# lumina-par — Design Document

ai-ee v1 pipeline

### Requirements: lumina-par (LUM-DTR-PAR-A / LUM-PAR-A)

reports/renders/lumina-par\_top.png

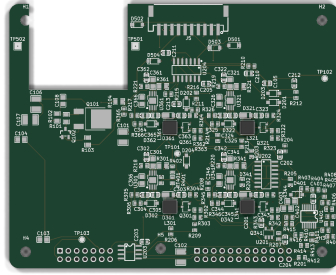
**W2. The right-hand 12 mm strip has no reference plane at all - and the independent over-temperature comparator lives in it** Both pours stop at board-local  $x = 88$  over the full 80 mm height (zone outlines (54.937, 57.192)-(142.937, 137.192) on In1 and In2). ICD s7.6 only reserves y 25-55 in that column. The removal outside 25-55 is a choice, not a constraint.

U401 (LM339LV, TSSOP-14) spans board-local x 89.1-93.0, y 61.5-67.1 - \*\*6.5 mm clear of the reserved column and entirely off both planes\*\* - with R403-R416, C401-C403 and D401 around it. Measured in the (84, 54)-(100, 78) box: 50.0 mm2 of In1 GND (all of it at  $x < 88$ ), 6.1 mm2 of F.Cu GND, 0.9 mm2 of B.Cu GND and **4 GND vias**. Over the whole  $x > 88$  strip (956 mm2 of board) there is 2.39 mm2 of F.Cu GND and 0.83 mm2 of In1 GND.

The cause is visible in `lumina-par_top.png`: the whole left third (x 0-36, y 26-80) is empty apart from the DNP branch-B front end, while the analog block is squeezed out past the plane edge at x > 88 (W2) and 42 refdes collide (W5). The annealer had a large free region and used it for the parts that least needed it.

The plane can legally be restored at  $x$  88-100 for  $y < 23$  and  $y > 57$ , which covers the whole analog block while leaving the ICD column void intact.
